[Docket No. 2004-NE-07-AD; Amendment 39-13579; AD 2004-08-10]

Airworthiness Directives; Engine Components Incorporated (ECi) Reciprocating Engine Cylinders

ACTION: Final rule; request for comments.

2004-08-10 Engine Components Incorporated (ECi): Amendment 39-13579. Docket No. 2004-NE-07-AD.

Figure 1.

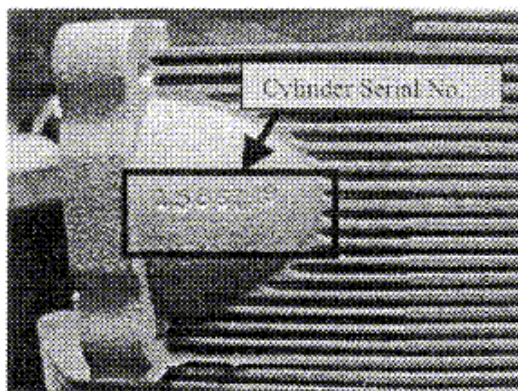
(i) Determine the SN of the cylinder by looking in the engine records or by inspecting the cylinder for a SN on the intake port boss (see Figure 1) or on the flat area next to the head to barrel junction (see Figure 2). Disregard any dash numbers that might follow the four digit SN.

Figure 3.

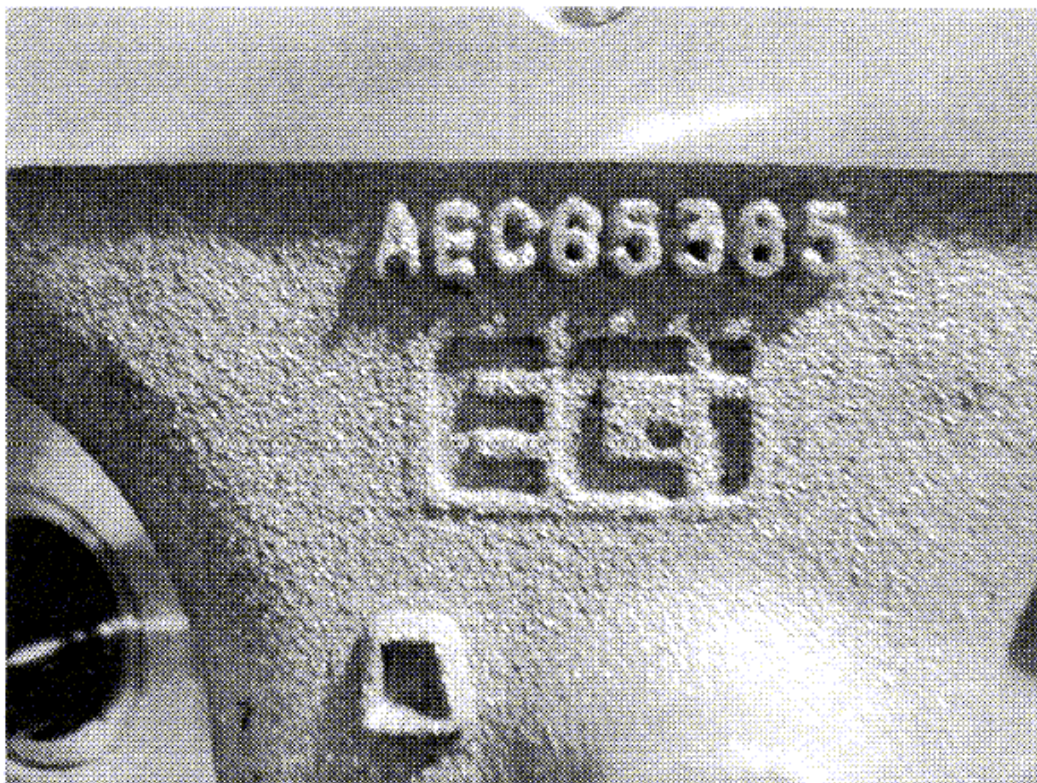
- (ii) If the SN is 1043 or lower, or if it is 7709 or higher, no further action is required.
- (2) If the cylinder SN is 1044 through 7708, do the following:
 - (i) Remove the rocker box cover from the cylinder.
 - (ii) Look at the left-front cylinder casting.
 - (iii) If the casting has AEC65385, and an "O" under the ECi logo, the cylinder is P/N AEC631397. See Figure 3.

Figure 4.

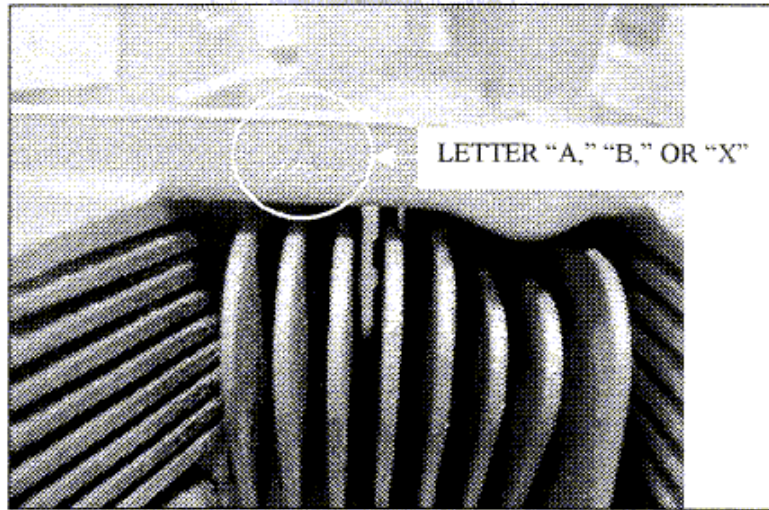
- (iv) If the cylinder is not ECI P/N AEC631397, no further action is required.
- (3) If the cylinder is ECI P/N AEC631397, do the following:
 - (i) Look at the flange of the rocker box.
 - (ii) If there is a letter "A," "B," or "X" stamped on the flange of the rocker box, no further action is required. See Figure 4.

- (iii) If there is no letter "A," "B," or "X" stamped on the flange of the rocker box, replace the cylinder before further flight.
